October 18, 2019

**Subject: Comments on Tentative Order for City of Thousand Oaks, Hill Canyon Treatment Plant**

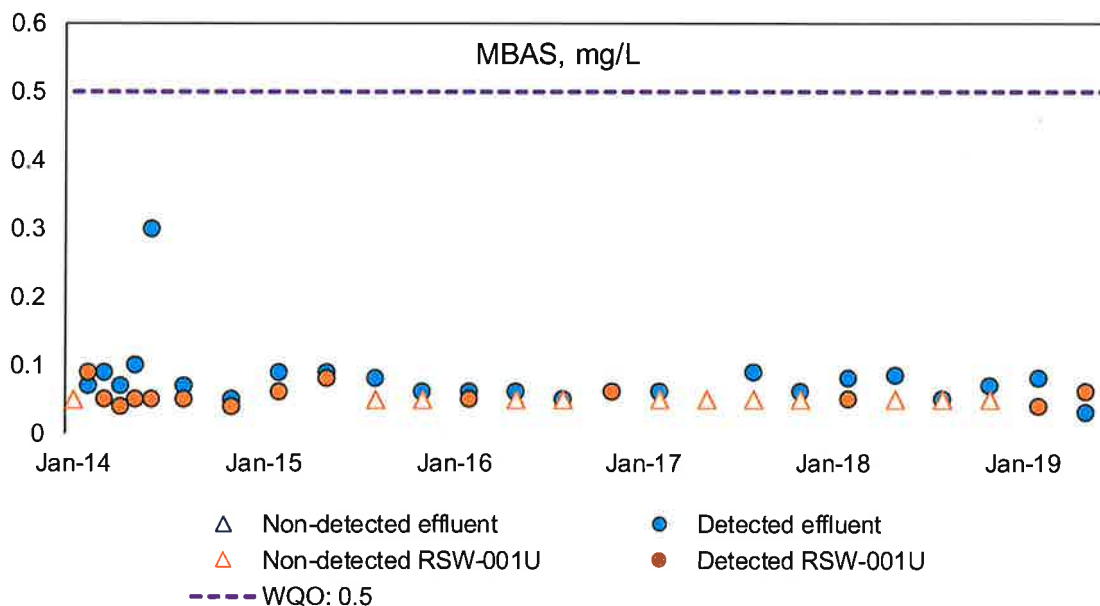
The City requests that the wet weather effluent limitations for TDS, sulfate, and chloride in Table 4 be removed because there is no reasonable potential for the effluent to cause or contribute to a water quality exceedance for salts during wet weather. Attachment F, Section IV.C.2.b.vi. on pg. F-25 of the Tentative Order states that, during wet weather, the limits for TDS, sulfate, and chloride are based on the water quality objectives found in Basin Plan Table 3-8. However, as noted in the dry weather definition found in Section VII.O. (pg. 32), "Any discharges from the Facility during wet weather would be assimilated by these large storm flows and would not cause exceedances of water quality objectives." Therefore, no reasonable potential exists during wet weather to

exceed the water quality objectives for TDS, sulfate, or chloride and no effluent limitation is required for wet weather. 40 C.F.R. §122.44(d)(1)(i) and (iii).

Additionally, the CCW Salts TMDL specifically identified that only dry weather allocations were needed to address any identified impairments. Therefore, only dry weather effluent limitations for TDS, sulfate, and chloride are needed to implement the CCW Salts TMDL WLAs.

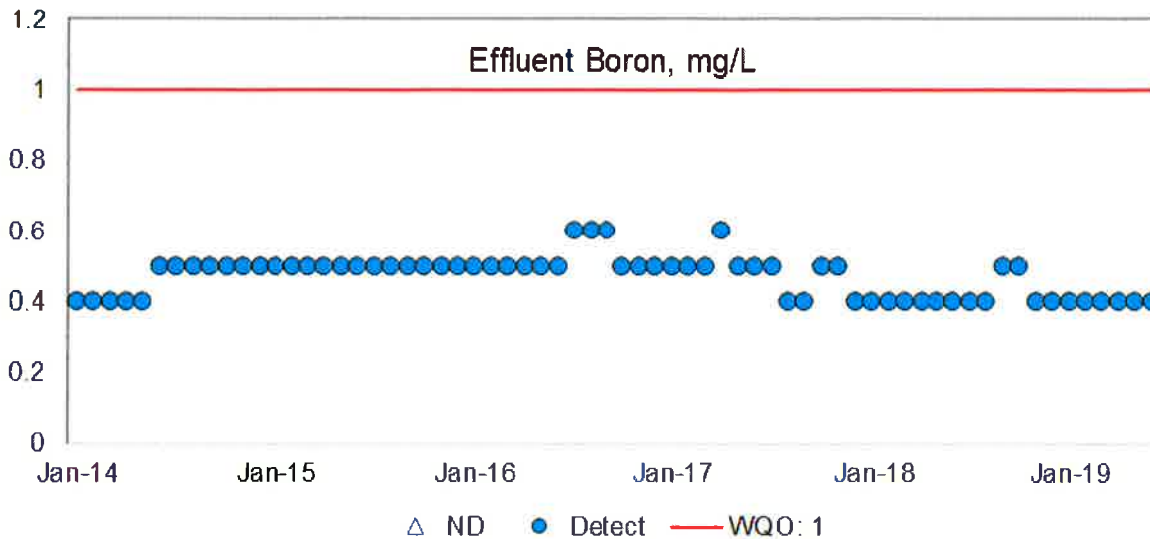
As shown below, boron also does not have reasonable potential to exceed the objective of 1 mg/L with a maximum effluent concentration of 0.6 mg/L and a maximum ambient concentration of 0.5 mg/L. Additionally, the Salts TMDL does not include a WLA for boron because there were no exceedances of the objective in the receiving water or effluent at the time of TMDL development. Therefore, the City requests that the effluent limit be removed.
